# Statement of Expert Evidence Urban Design

Amendment C175  
**Whitehorse Planning Scheme**

On behalf of  
**Box Hill Institute**

Prepared by  
**Amanda Roberts**  
**SJB Urban**

Figure 13: Sub Precinct F6 Proposed Landscape Setbacks

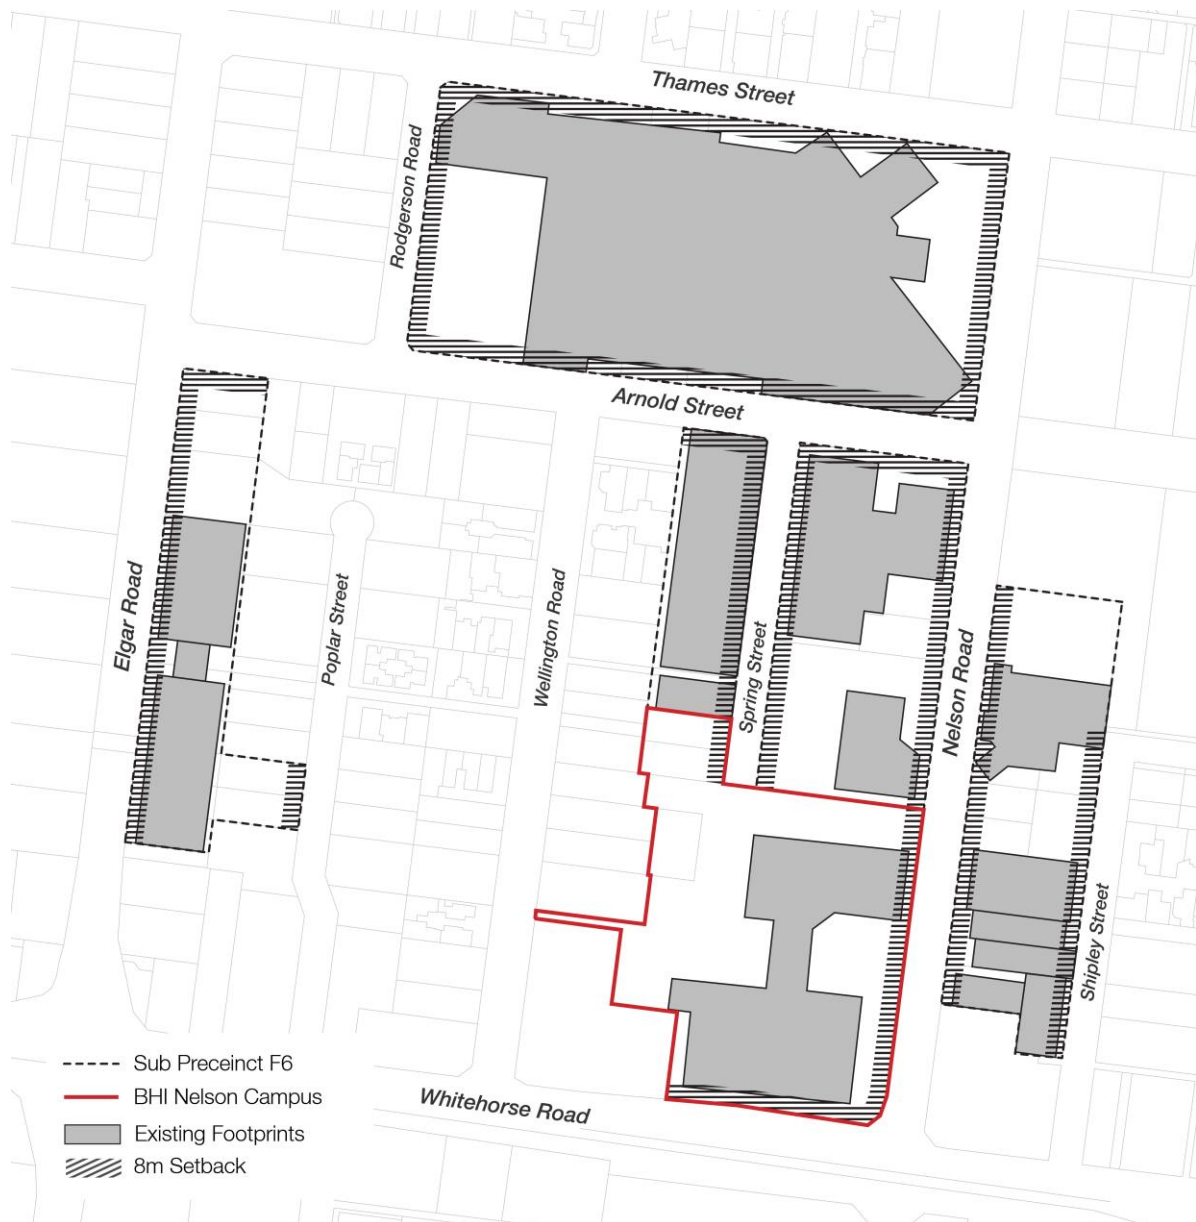
[ 95 ] It is also noted that the Nelson Campus is identified within *The Guidelines* as an 'extra large' allotment (>2,500sqm). The Built Form Response for Sub Precinct F6 states '*a plot – ratio approach is applicable on extra large sites*'. Further clarification of a plot ratio is not provided. It is noted that this is within the Urban Design attribute 'subdivision pattern' not 'street walls and preferred maximum height' which makes its application more obscure.

[ 96 ] In summary, the sub-precinct guidelines for F6 have, in my opinion, been applied to this precinct as a direct result of an assumed character of 'campus design'. This character, as discussed above and in my opinion, is incongruous with a good urban outcome which considers the Health and Education Precinct as an integrated and essential component of the community it serves.

Figure 15: Height Transition Analysis – Sections. As can be seen in the top two sections, the existing and C175 proposed transition from the height located around Whitehorse Road to the north is abrupt. The bottom diagram shows a more considered and appropriate built form.

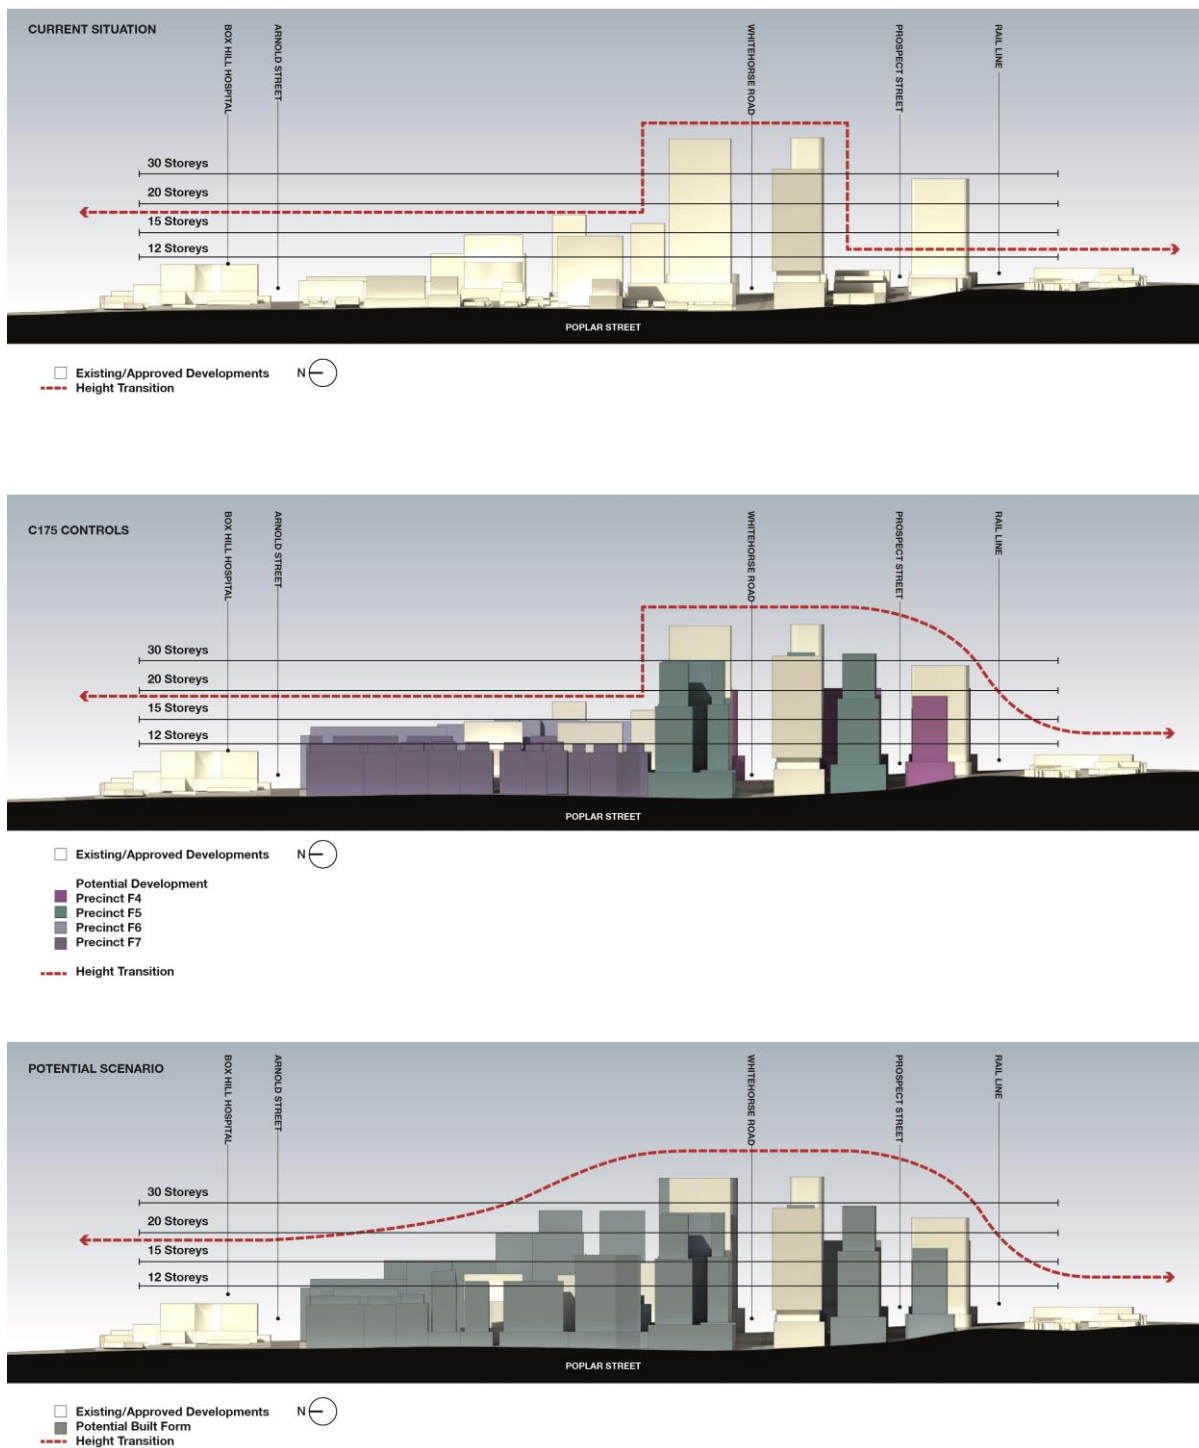
- [ 101 ] There is, in my opinion, no urban justification for this change in height guidance, hence my assumption that the existing land use (institutional) and the existing built form has led to a character assumption that is lower in height than the surrounding city.

- [ 102 ] The height of buildings, podium setbacks and side and rear setbacks, in my opinion, should also be considered in their capacity to meet other standards including access to light and natural ventilation, impact on the streetscape and street ratio and how they provide a transition from high to medium to low scale development.

- [ 103 ] In summary, I would suggest a more nuanced and transitional height control would be more appropriate for Precinct F6 and would allow the Health and Education Precinct to become an integrated part of the city form.
